Federal Motor Vehicle Safety Standards; Electronic Stability Control Systems; Controls and Displays

ACTION: Final rule; response to petitions for reconsideration.

Figure 1. Rotary Multi-mode Control Example

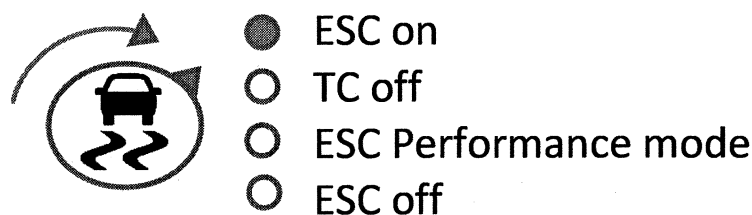
The Alliance/AIAM offered the example of a multi-function control that could be used to turn ESC off or on, but could also be used to turn traction control off and to select an ESC “performance mode.” Because such a control could be seen as neither a control whose only purpose is to disable ESC, nor a control for another system with an ancillary effect, petitioners requested that the agency clarify that multi-function controls like the one described are not prohibited by FMVSS No. 126. Figure 1 below shows a rotary multi-function control (this example was provided in the petition).

Agency response: We are granting the petition to clarify S5.4.3, although we note that this question was already answered in the affirmative in the agency’s response to the GM request for interpretation. FMVSS No. 126 does not prohibit multi-function ESC controls that combine the control whose only purpose is to disable the ESC system with controls used for other purposes. Paragraph S5.4 specifically allows controls whose sole purpose is to disable ESC and establishes various requirements for them. The only reason that the standard distinguishes between these controls used only for disabling ESC from those used to control systems with an ancillary effect on ESC is to express the labeling requirements for the control symbols. The multi-function control example presented by the petition combines several controls in a single piece of hardware: one control whose only purpose is to disable ESC, one unregulated control for the traction control system, and another control that places the ESC system in an intermediate “sport” or “performance” mode.”

In the rotary multi-function control example of Figure 1, the function within the control that disables ESC, because its only purpose is to disable ESC,

would be required to be identified using the symbol or text specified in FMVSS No. 101 for “ESC Off” (effective September 1, 2011) on or adjacent to that part of the control. We would not consider the precise example given by the Alliance/AIAM petition as satisfying FMVSS No. 101’s requirement that the “ESC Off” label (“identifier”) be adjacent to the control it identifies, because the telltale lamp is located between the two.¹⁶ However, this problem could be solved by moving the lamp to the other side of the label.

FMVSS No. 126 does not specify requirements for the “TC off” function in the example, nor for the “ESC Performance mode” function, unless that function within the control places the ESC system in a mode in which it no longer satisfies the standard’s performance requirements. If it did, it would be considered an “ESC Off” control (because it is a control whose purpose is to place the ESC system in a mode in which it no longer satisfies the performance requirements) and would also have to be labeled accordingly.
